## Product Change Notification / SYST-23UFEG663

ERRATA - KSZ9131RNX Silicon Errata and Data Sheet Clarification

## Silicon Errata and Data Sheet Clarification

**FIGURE 1: TOP MARKING DATE CODE INDICATION**

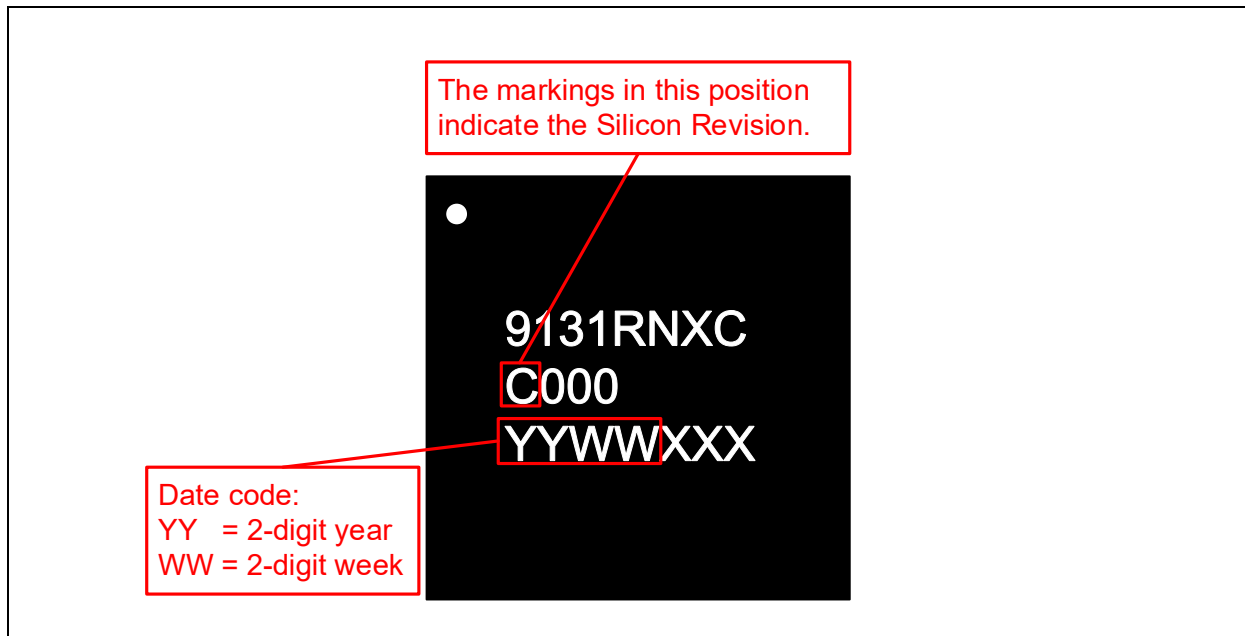
Revision Level & Date	Section/Figure/Entry	Correction
DS80000693C (02-23-22)	Module 3	Added <b>Module 3 : 1000M EEE needs 100M Advertisement Enabled</b>
	Table 1, Table 2, and Figure 1	Changed silicon revision letter from "C0" to "C."
DS80000693B (07-19-21)	Module 2	Added <b>Module 2 : LED1 in Single-LED Mode Behaves Incorrectly</b>
DS80000693A (10-21-19)	All	Initial release
